TOWN OF BAY HARBOR ISLANDS MORRIS N. BROAD COMMUNITY CENTER

**DEVELOPMENT & REVIEW COMMITTEE MEETING
THURSDAY, MAY 9, 2024**

Subject: Site Development Plan Application - #1 Review & Comments
10150-10190 East Bay Harbor Drive & 1075 101 St. – 20 DU Townhouses
Bay Harbor Islands Acct. No. SPR2024-000011
MMPA Acct. No. 01-0702-1190

GROUND FLOOR
SITE PLAN

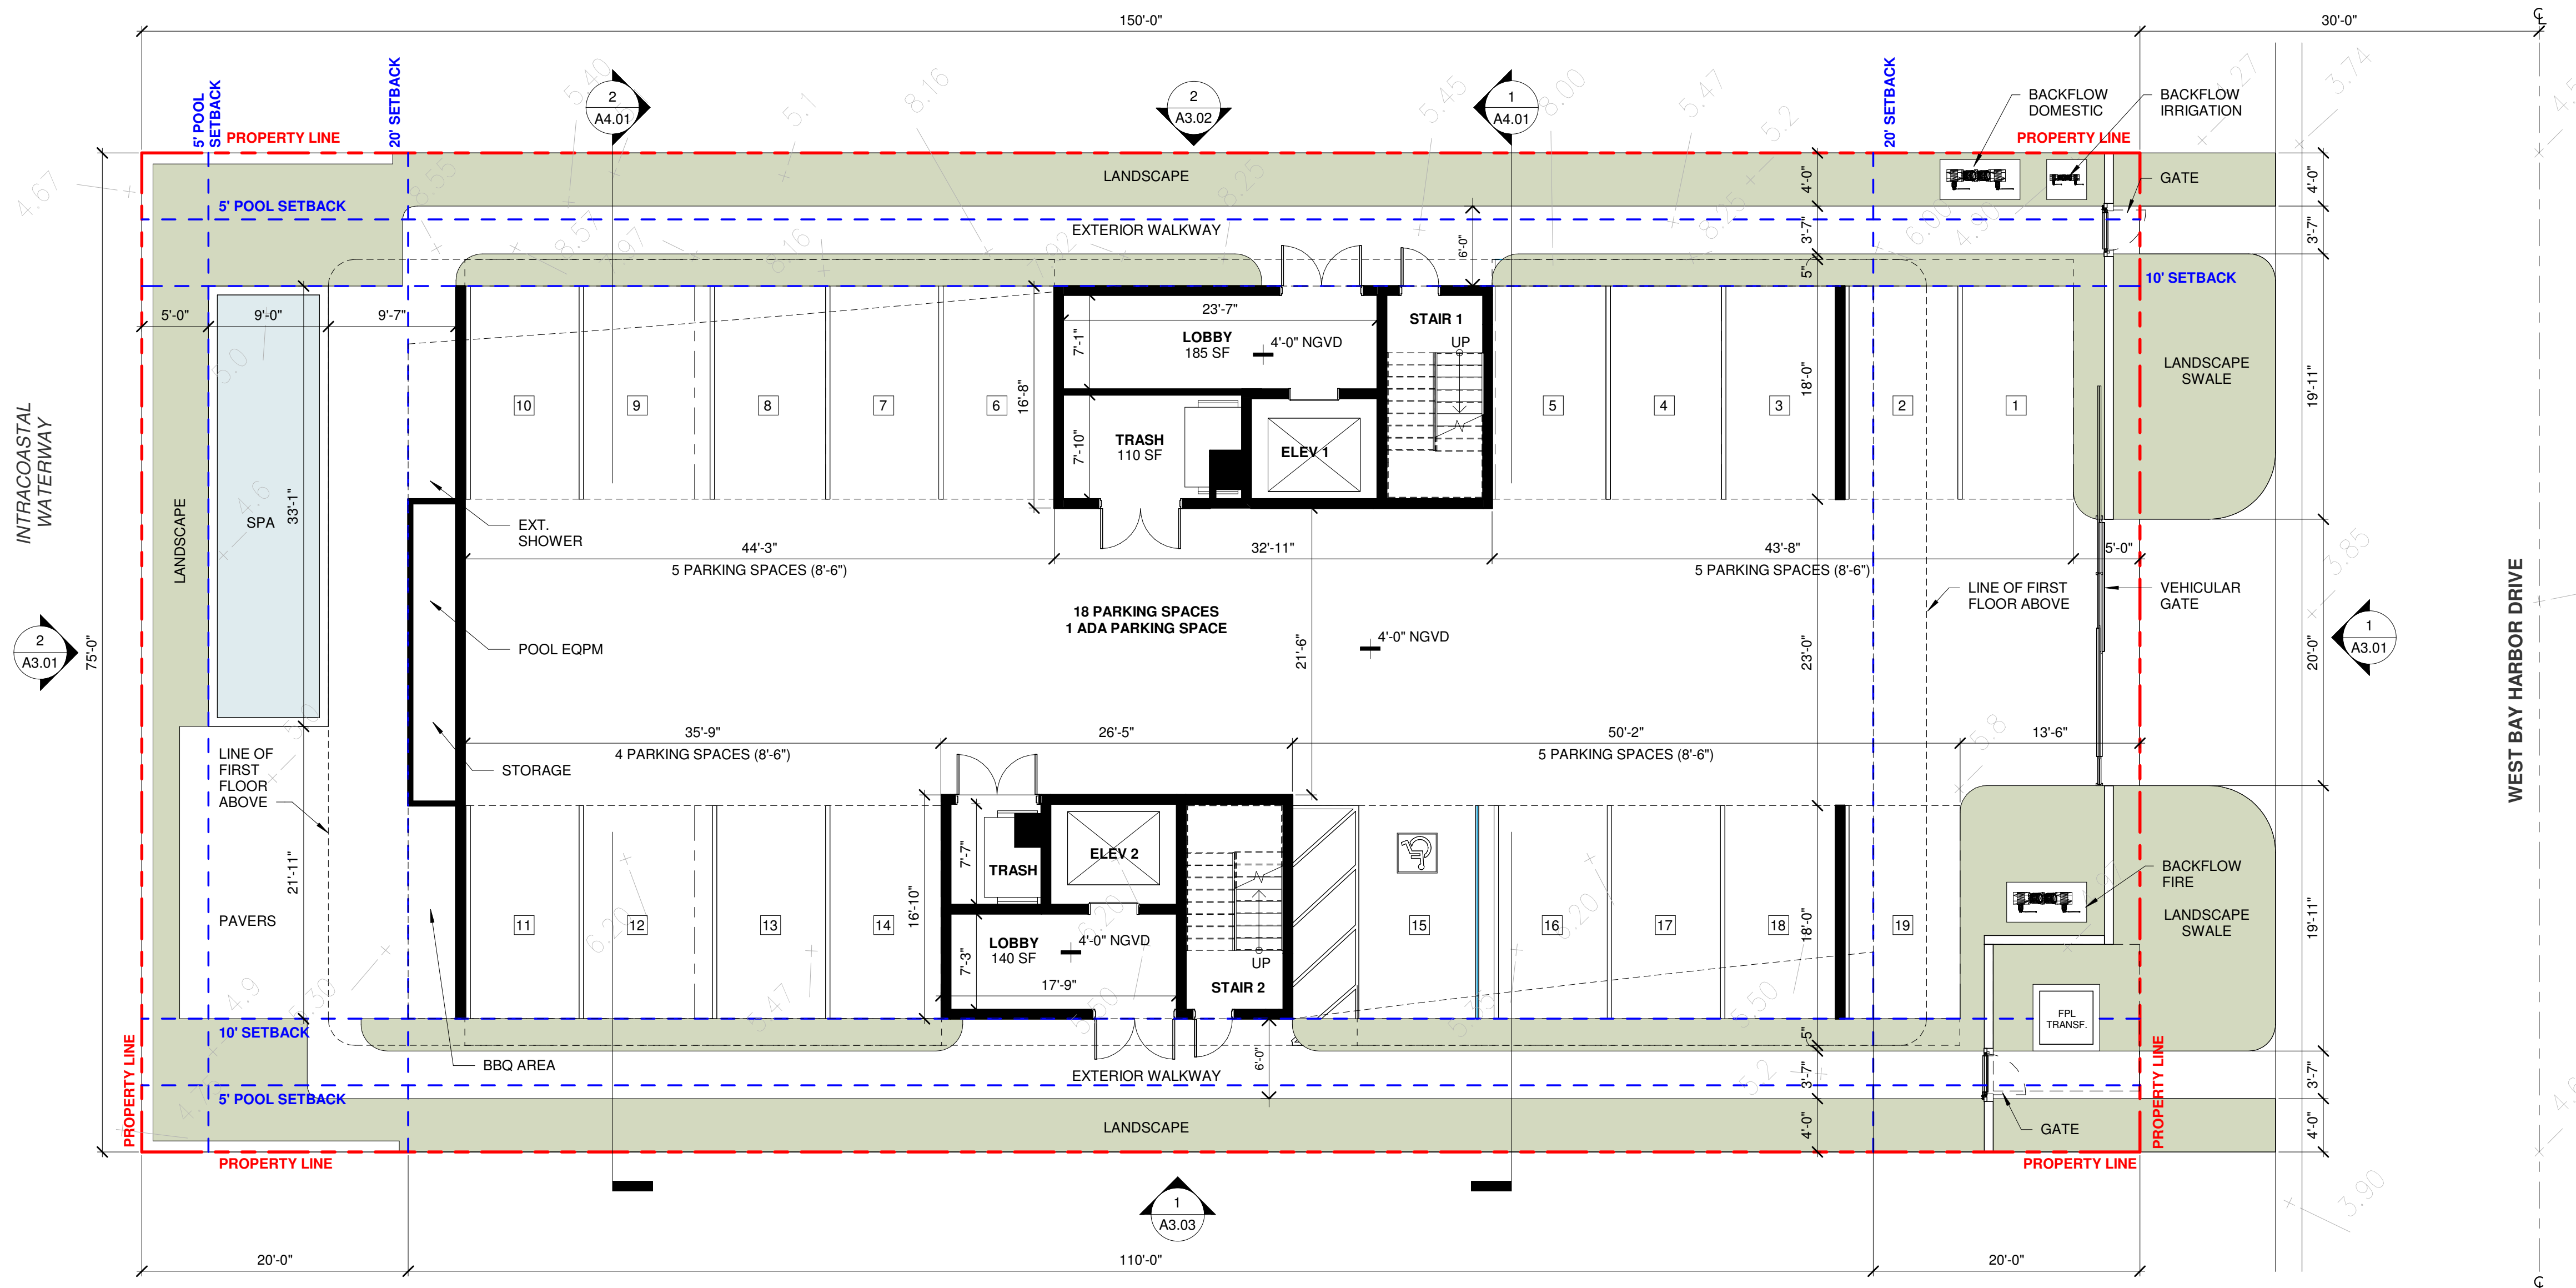
16. Dimension the parking spaces on Sheet A1.00 Ground Floor Site Plan. It appears the parking spaces are not the correct length of 18' of pavement (16'-10" shown) with some overhang into side yard setbacks. The Code requires that the entire parking space be paved. Also show any proposed screening walls or fences on the plans.

25. Site Plan Sheet A1.00 is not clear as the location of the proposed screening for the south & north sides of the open garage. Sec. 23-24(d)(4) requires that all parking garages be fully enclosed and if an alternative design is allowed it must substantially screen vehicles / other internal garage areas from neighboring sites for noise / light / odors. No mechanical ventilation is allowed to adjoining sites – roof ventilation is preferred.

A1.02

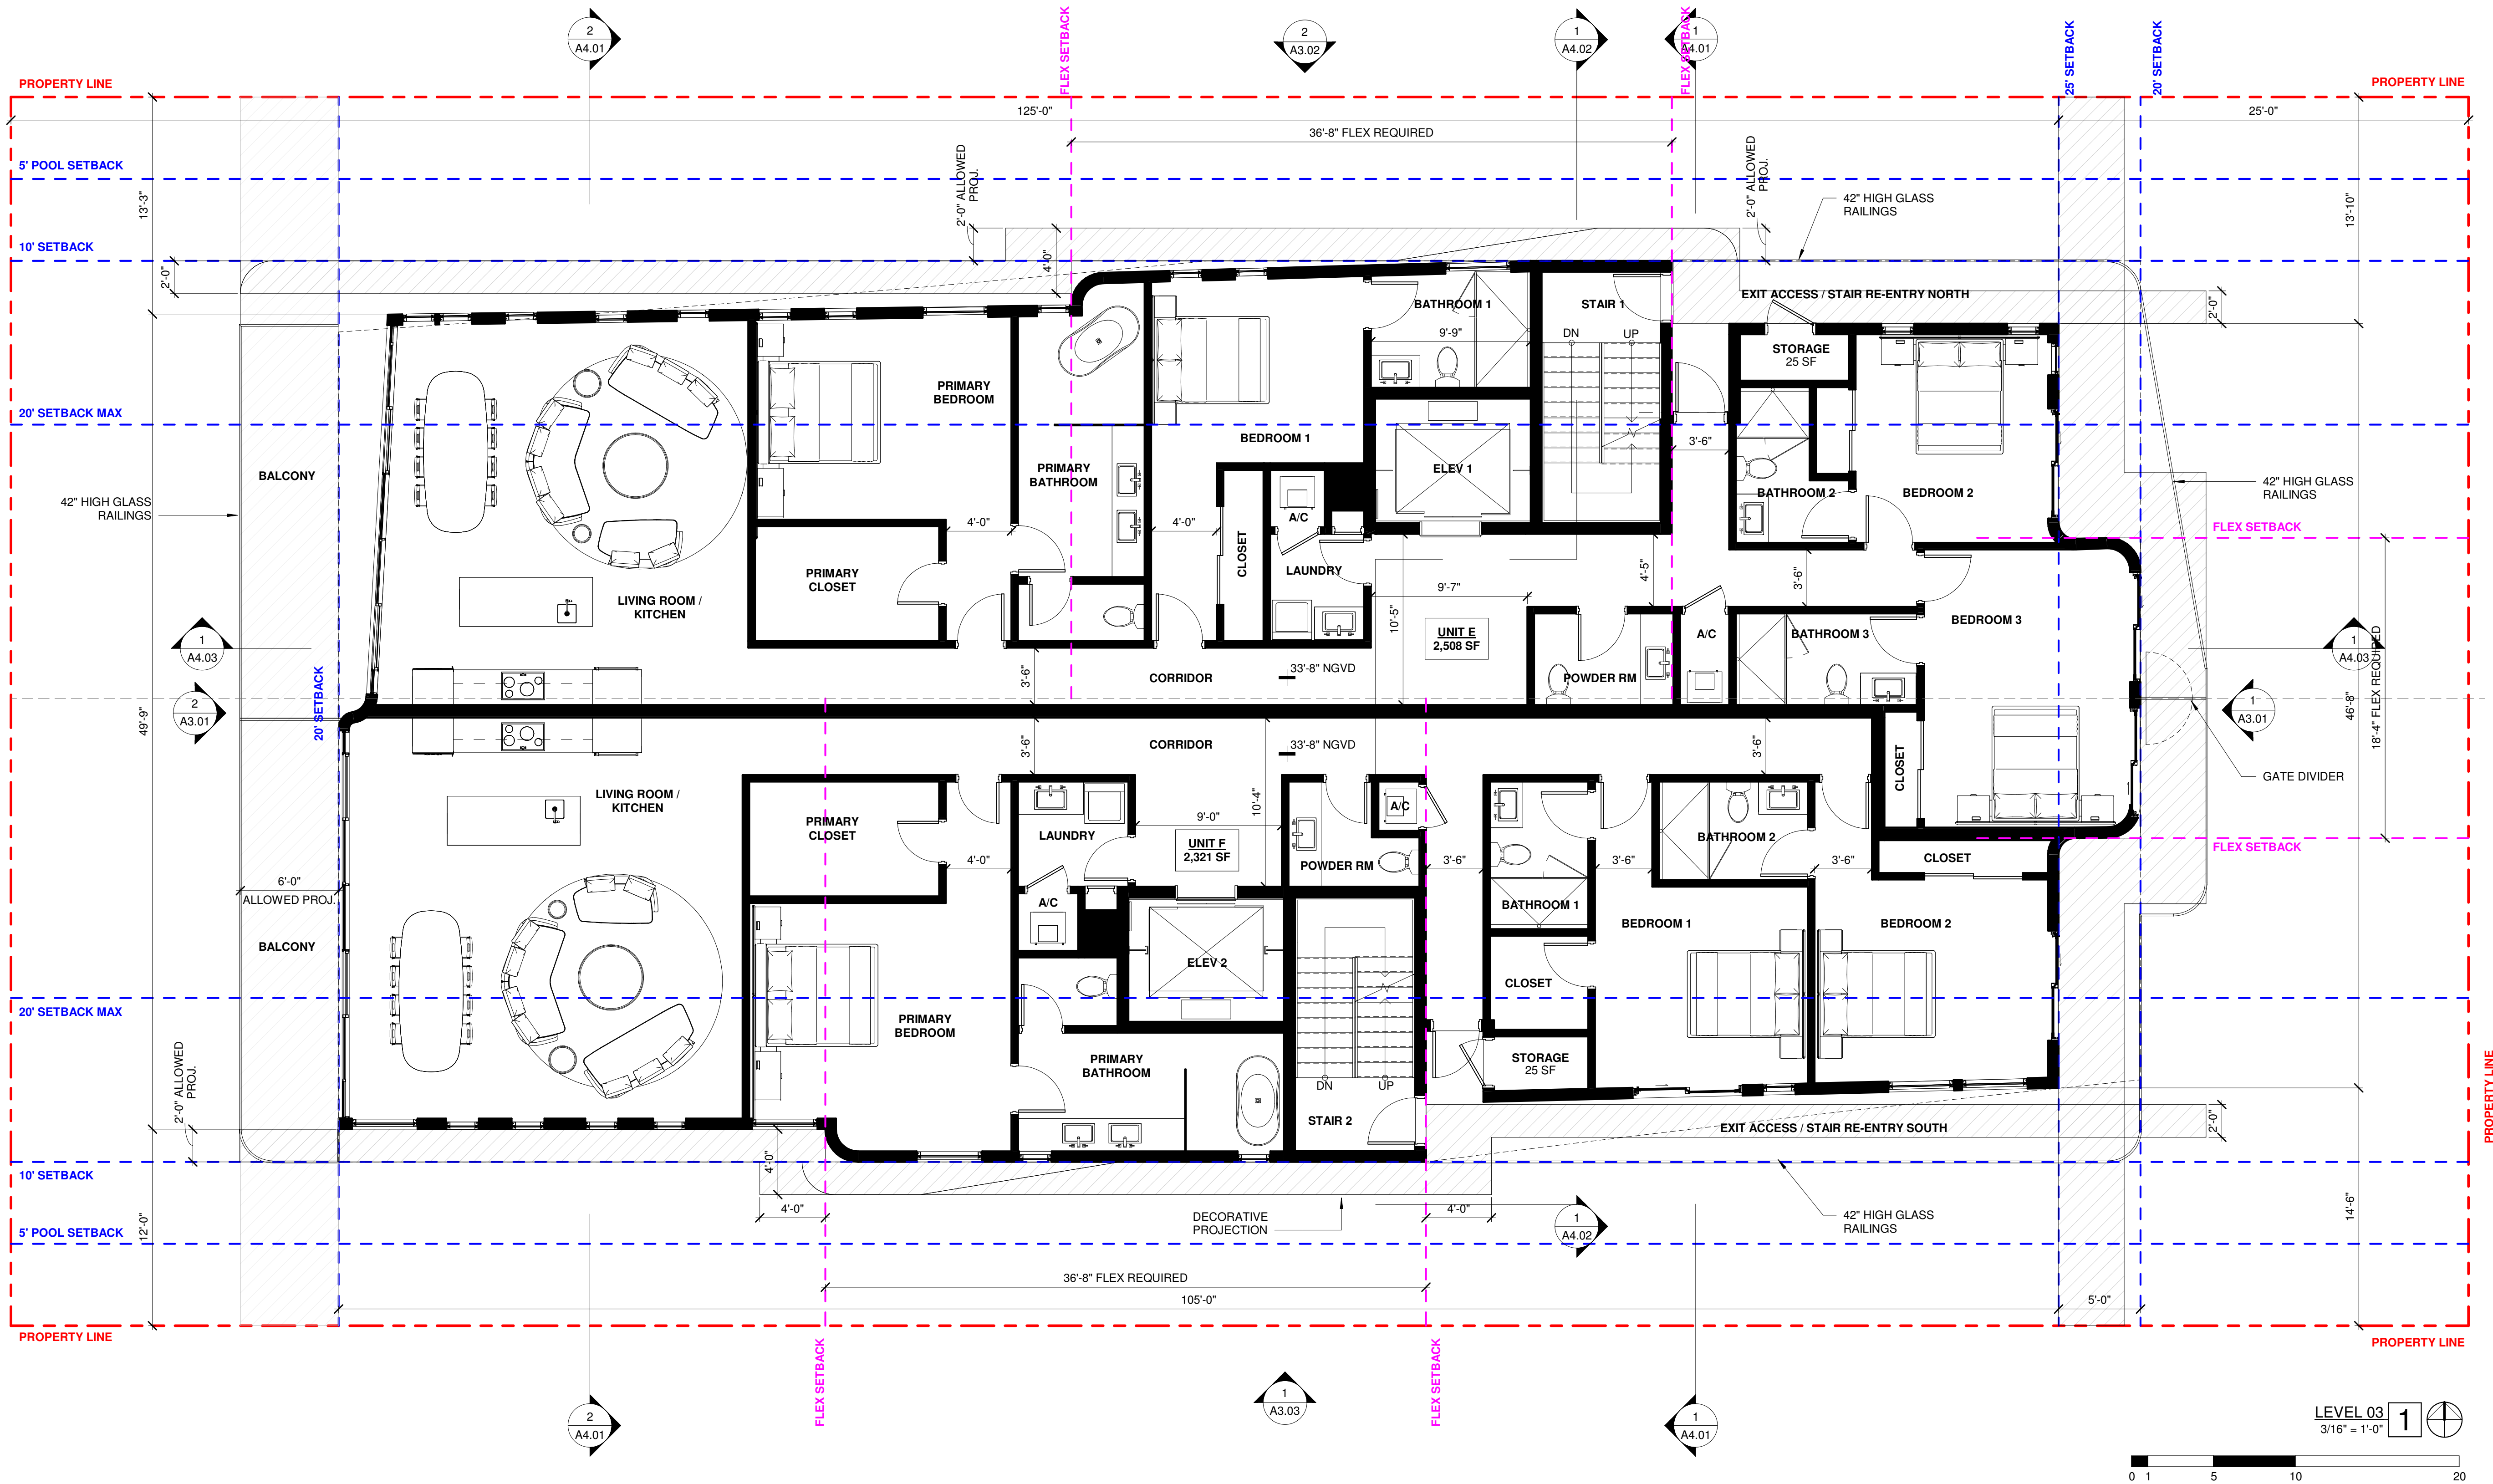
29. The type and location of a mail receptacle location is missing.
30. Sheet A1.02 Second Floor Plan, Unit C a bedroom appears to be labeled "Trash" - please revise to bathroom.
